Addendum / Addenda No./N° 2

Project Description / Description de projet				
O 77 Nov. Eibna Dhatanias Lasan La	L			
S-77 New Fibre Photonics Laser La	d			
Solicitation No./ No de sollicitation	Project No./N ^O de	oroiet	W.O. No./N ^O d'ordre de travail	
Control 110., 110 do como da con	i iojectivo./iv de j	projet	W.O. NO./N d ordre de travair	
13-22101	3894		9100024775	
Departmental Representative / représentant ministérie	el		Date	
2 opanimoniai representanto / representant ministeri	.			
Derek Foot			Jan. 13, 2014	
Notice:		Nota:		
This addendum shall form part of the tender documer	nts and all	Cet addenda fait partie intégrale des dossiers d'appel d'offres; toutes les		
conditions shall apply and be read in conjunction with		conditions énoncées doivent être lues et appliquées en conjonction avec		
and specifications.	and anginar prairie	les plans et les devis originaux.		
		Tank and an are

LIGHT SWITCHING ADDENDUM #2

date date scale échelle dwg.no. dessin no. 3894-SKE01 JAN 2014 1:100

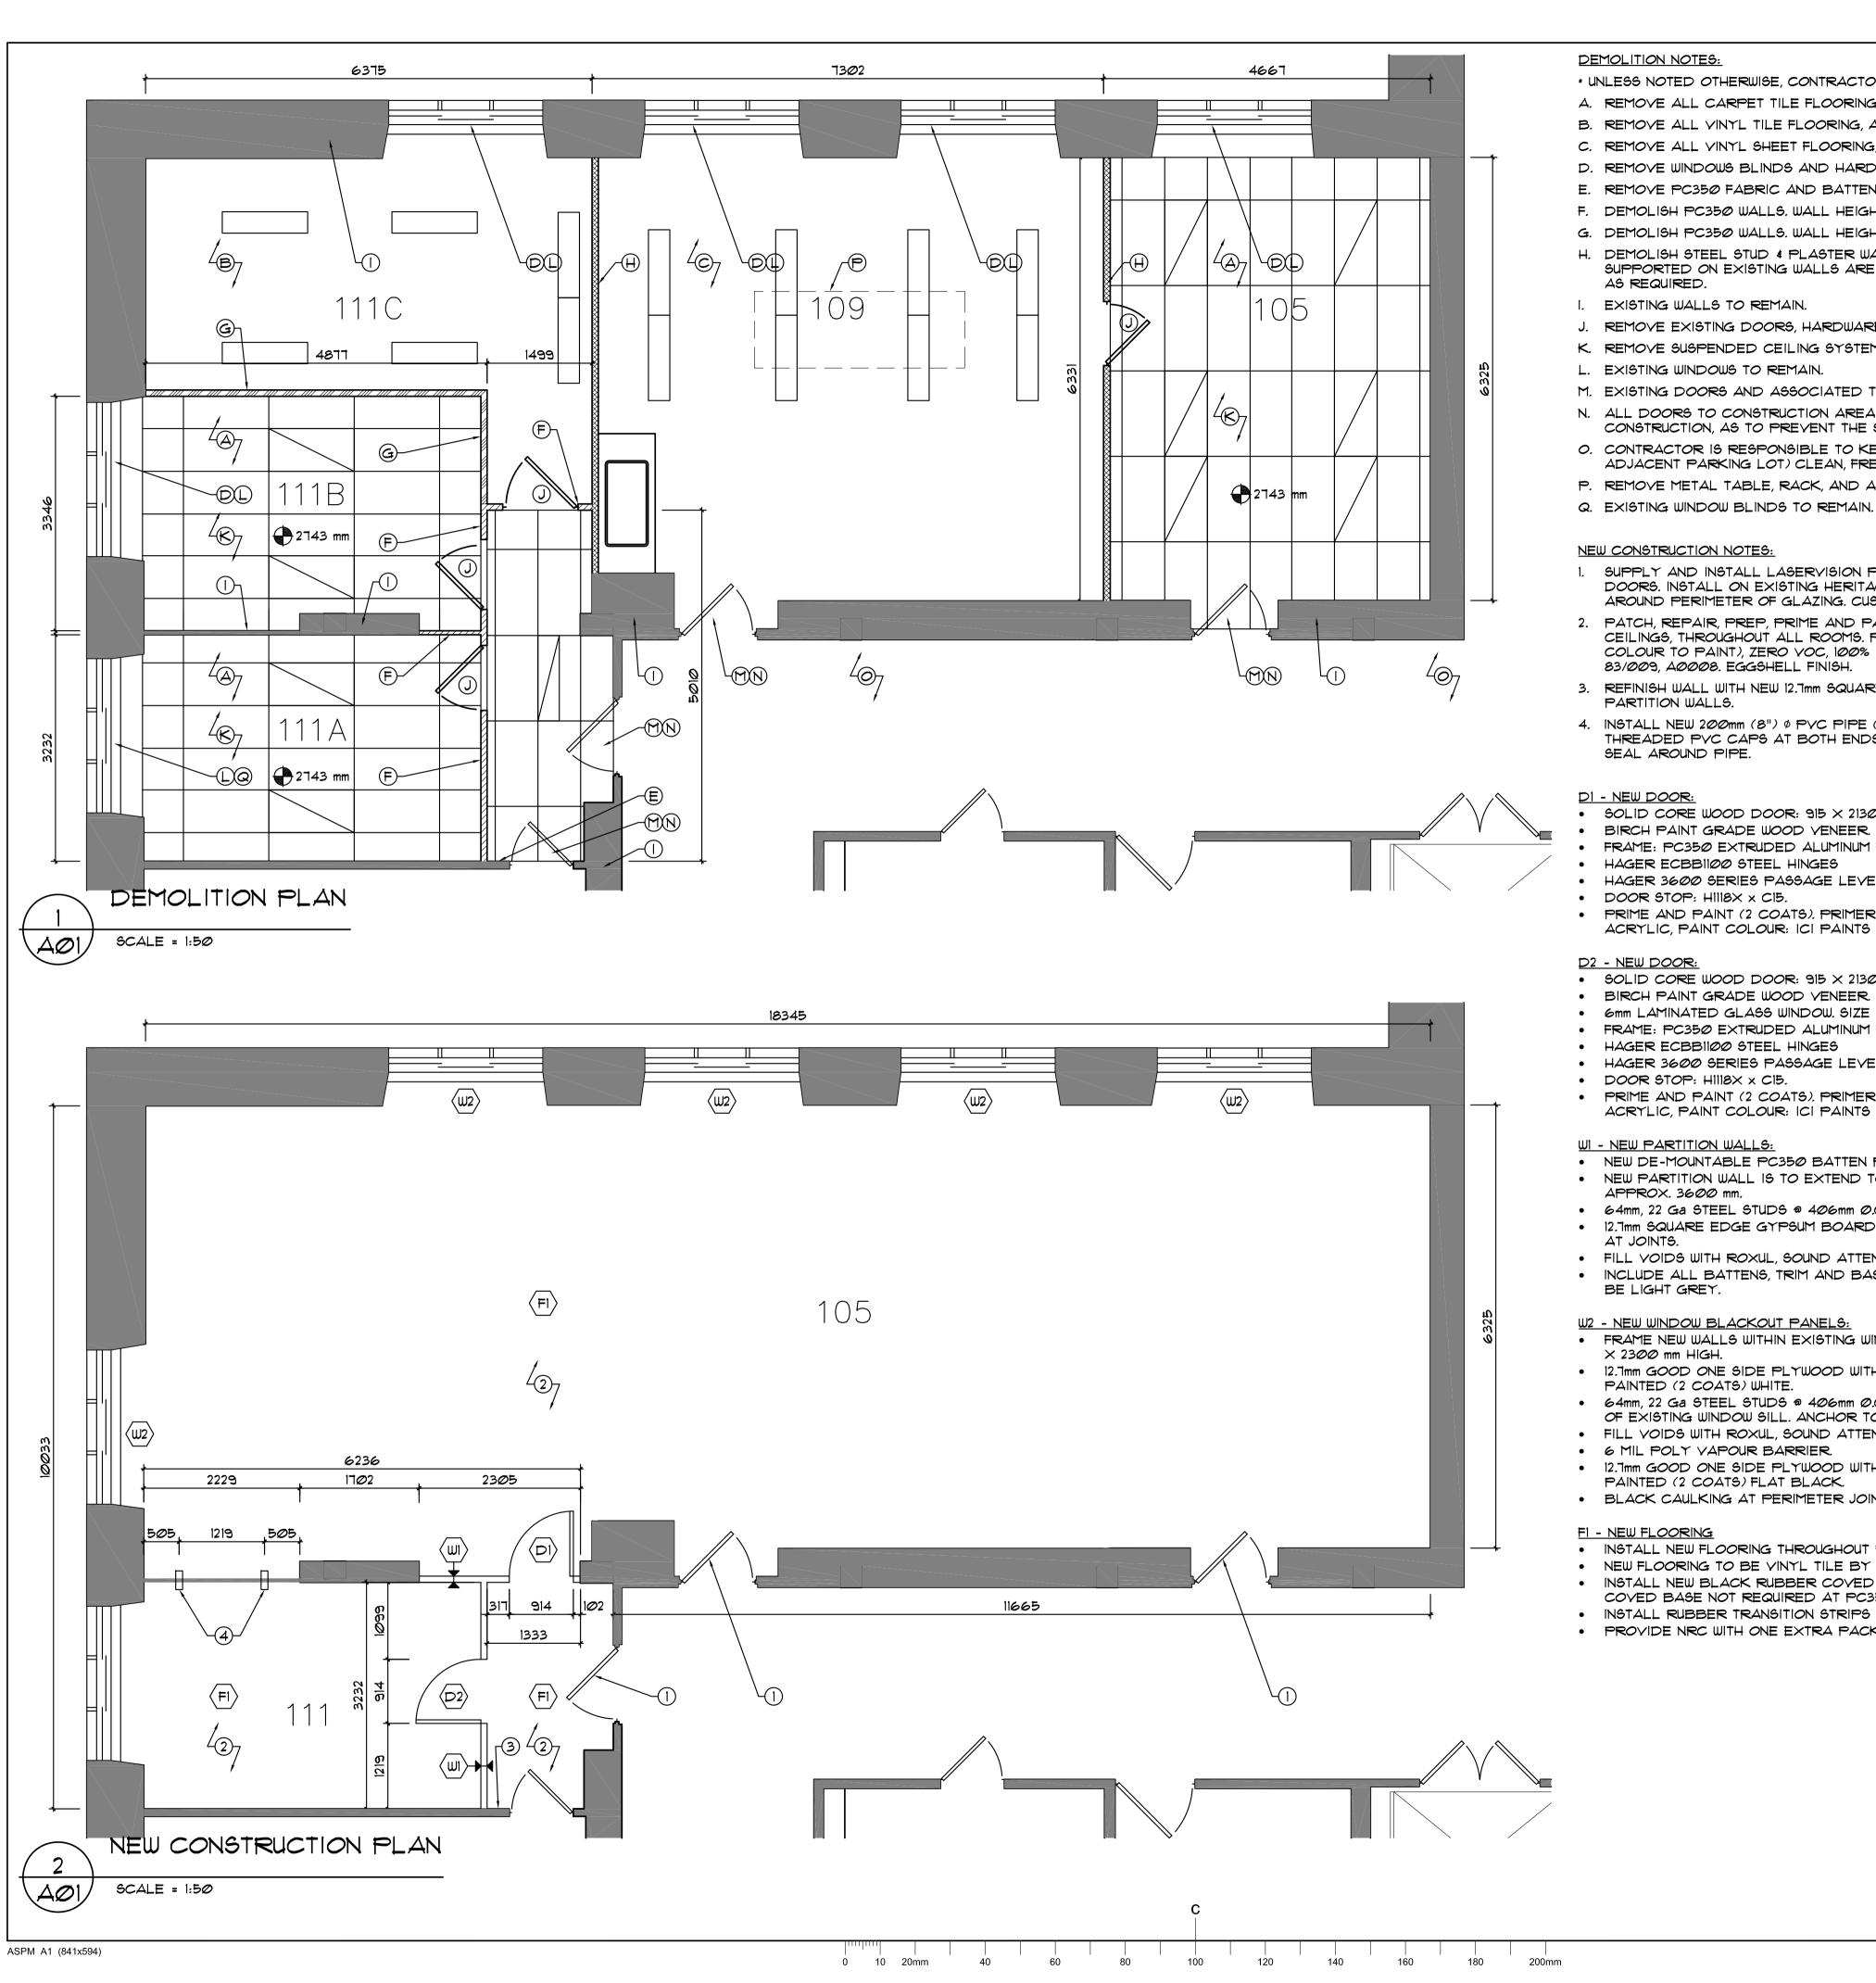
- 3. Specification section 265000.2.4.1.8 CREE CR-LE series is an acceptable alternate for light type A.
- 4. Specification section 265000 Light type A is to include 0-10v dimming.
- 5. Light switching in new room 105 is to be zoned as shown on attached sketch 3894-SKE01. Use 3x 0-10V dimming switches compatible with light fixture type A. Philips SR3W or equal.
- 6. Circuit Air cooled chiller referred to on drawing 3894-M03 from panel 105B. Size breaker and wire according to manufactuerers specifications. Coordinate with mechanical contractor for exact sizes.

3894-A01

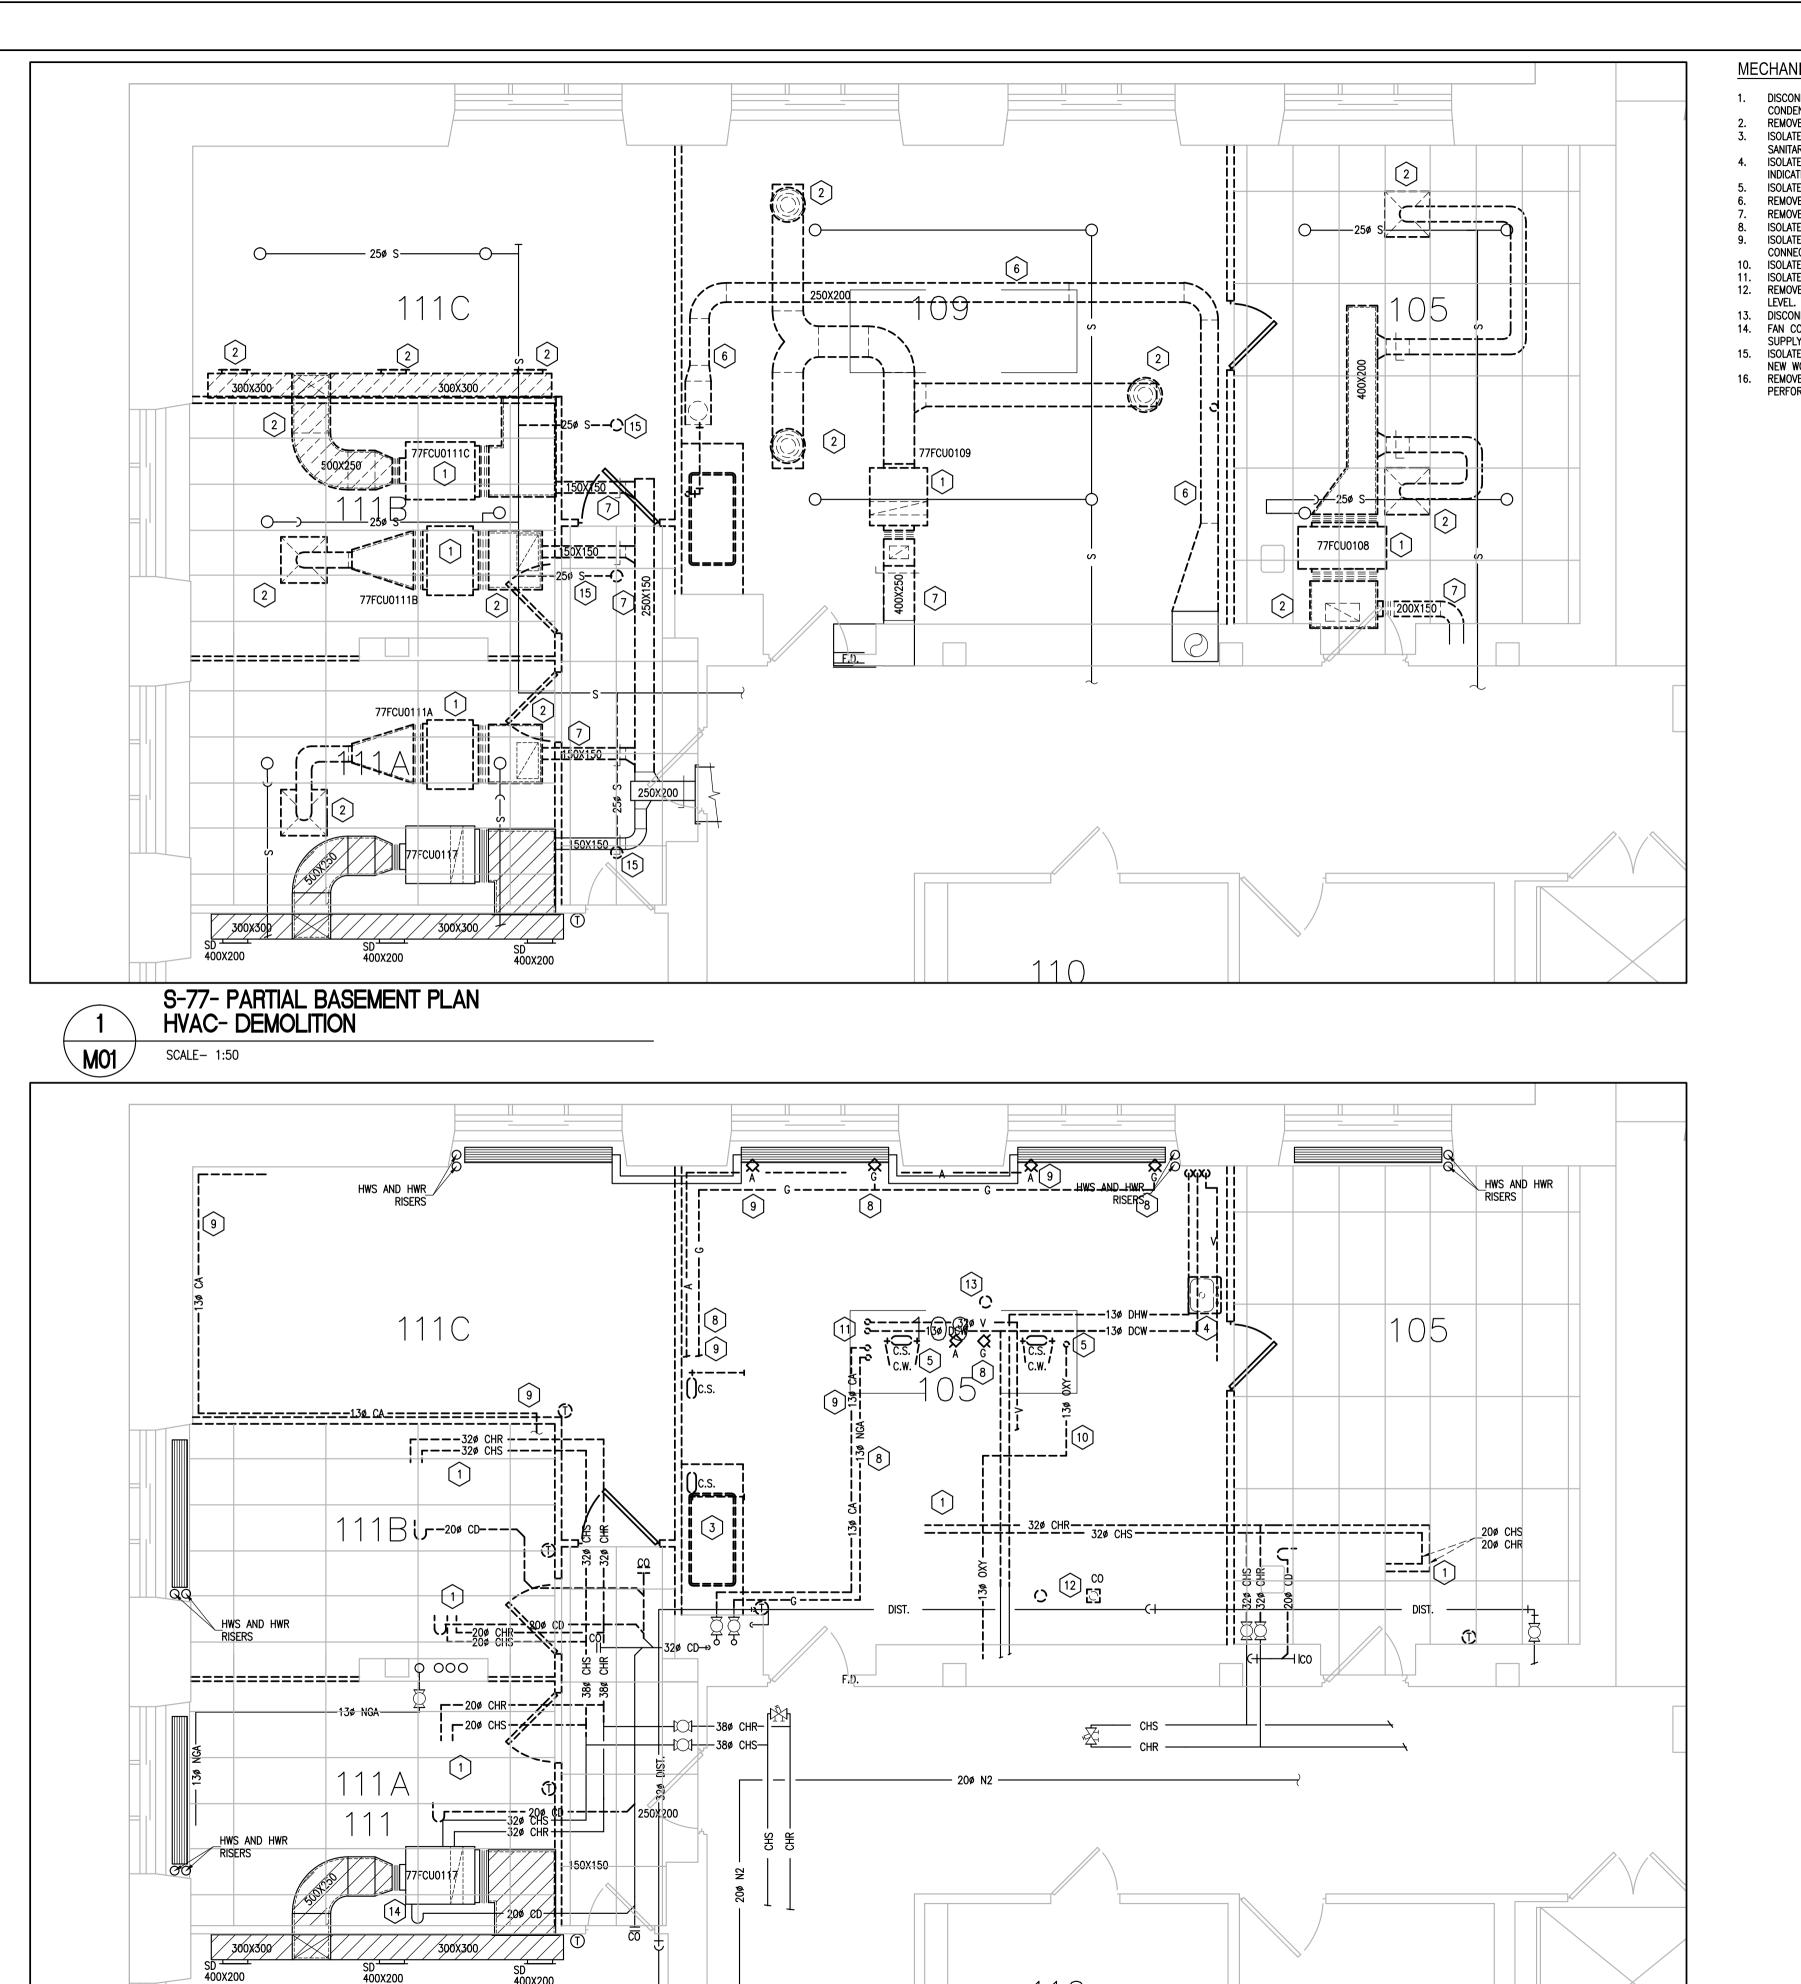
- 1. No coring through the floor or ceiling is required as part of this job.
- 2. Replace drawing A01 Issued for tender with drawings A01- Addendum #2 attached.

3894-M02

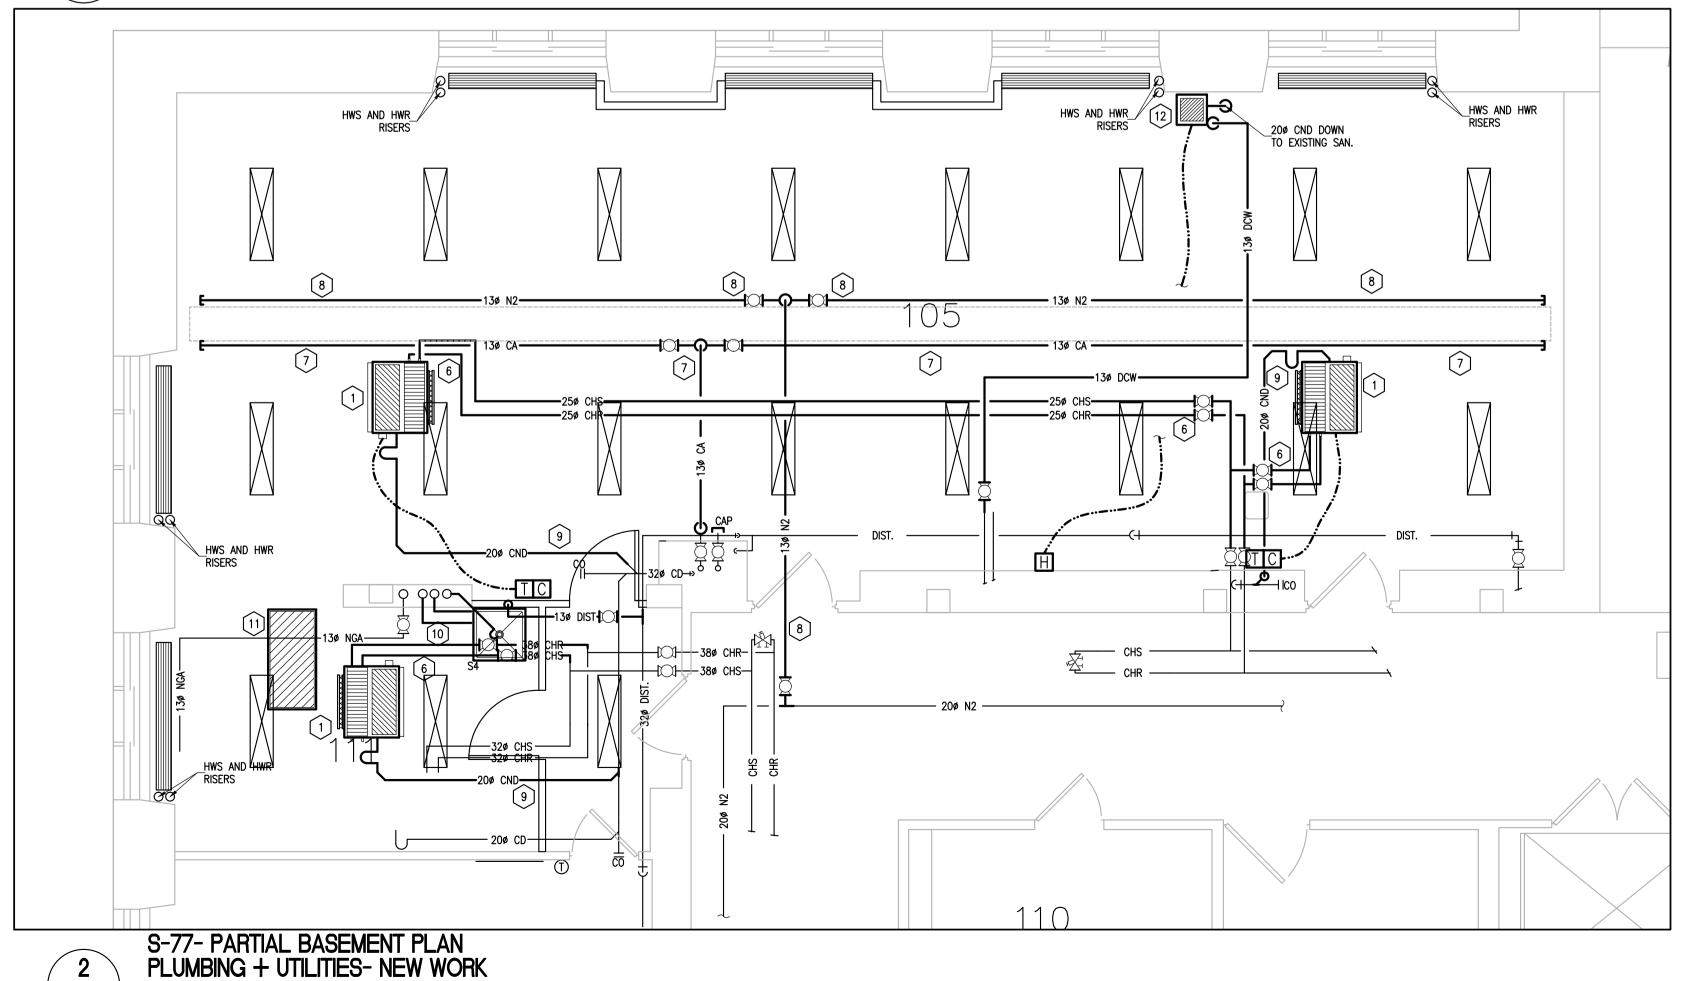
- 7. Replace drawings M01 and M02- Issued for addendum 1 with drawings M01 and M02- Issued for addendum 2 attached.
- 8. Sink S4 to be free standing stainless steel with no side ledge, basis of design is Franke SL2424-1 (nominal size 691mmx 691mm x 1119mm high (total), 356mm bowl depth) custom hole locations, faucets to be Chicago Faucet model 942-CP with model 317 handles and a Chicago Faucet model 870-BPVC for distilled water faucet offset to right of sink.
- 9. Provide 200mm diameter (8") exhaust duct from future gas cabinet location to existing exhaust duct as indicated on drawing M02.
